Technical Service Information

ALLISON 1000/2000 SERIES TRANSMISSIONS MODULATED LINE PRESSURE

CHANGE: Beginning with June 2003 production, a *Modulated Main Line Pressure* feature has been added to the Allison 1000/2000 series of transmissions.

Figure 1

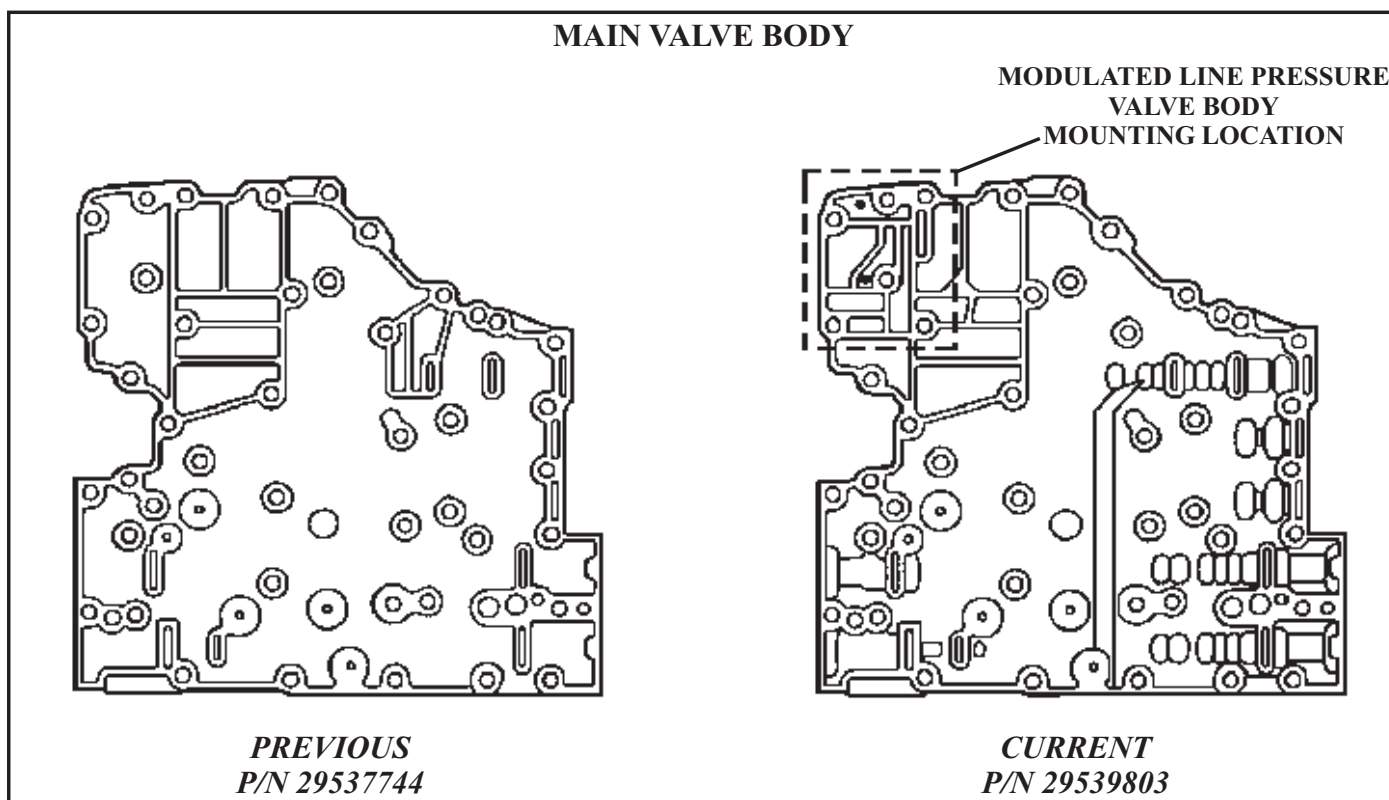
- (1)The Main Valve Body, (Figure 1), has changed as well as the Separator Plate, (Figure2).
- (2)The Shift Valve Body has changed, (Refer to Figures 3 and 4).

Figure 5

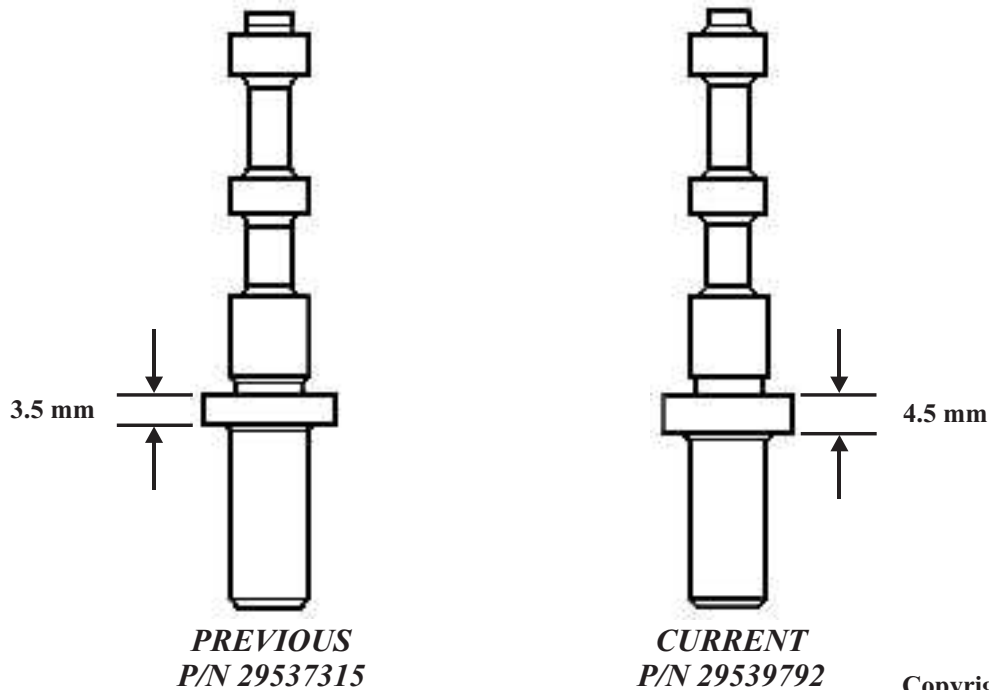
- (3)The Control Main Regulator Valve has changed, (See Figure 5).
- (4)The Main Pressure Regulator Valve has changed depending on application as shown in Figure 6.

Figure 7

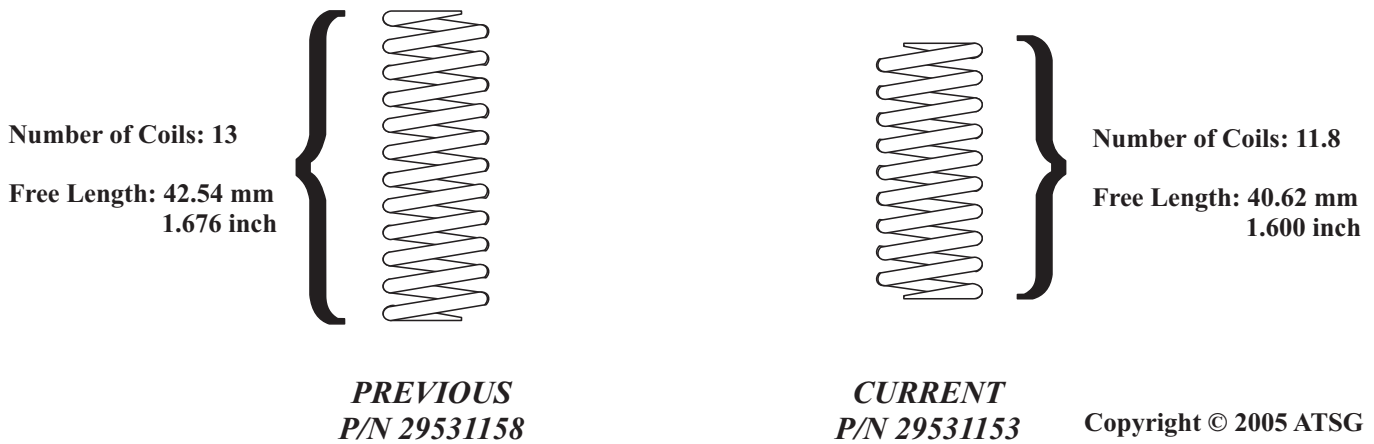
- (5)The Control Main Regulator and Control Main Relief Springs have changed dimensionally as shown in Figure 7.
- (6)A Modulated Main Valve Body has been added to accommodate the “G” Solenoid as seen in Figure 8).

Figure 9

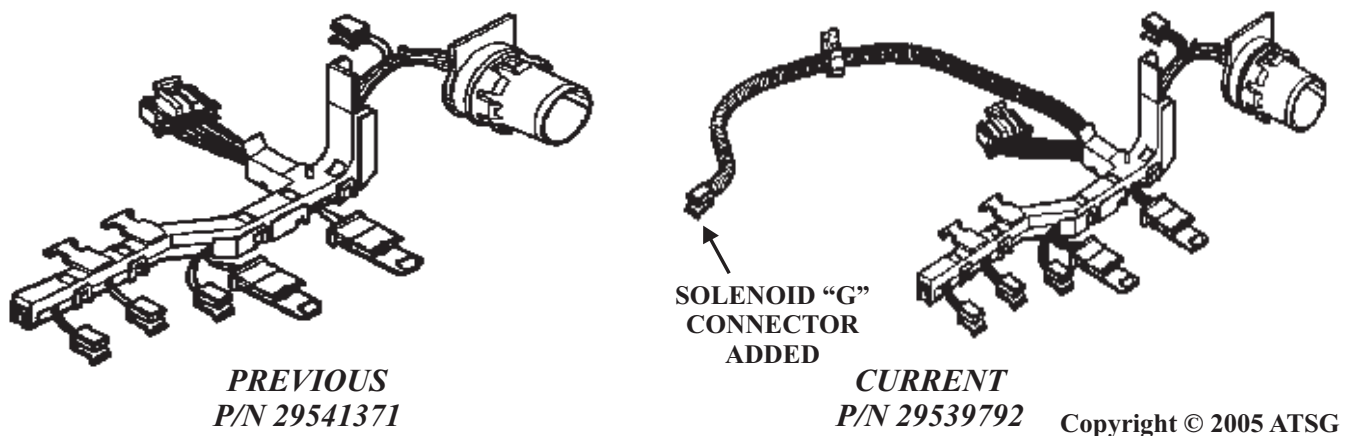
- (7)The internal wiring harness has been changed to accommodate the “G” Solenoid, (See Figure 9).
- (8)This feature also includes the addition of Solenoid “G” as well as the additional circuitry from case connector terminal “R” to the “J2” (RED) TCM connector at terminal 30 as shown in Figure 10.
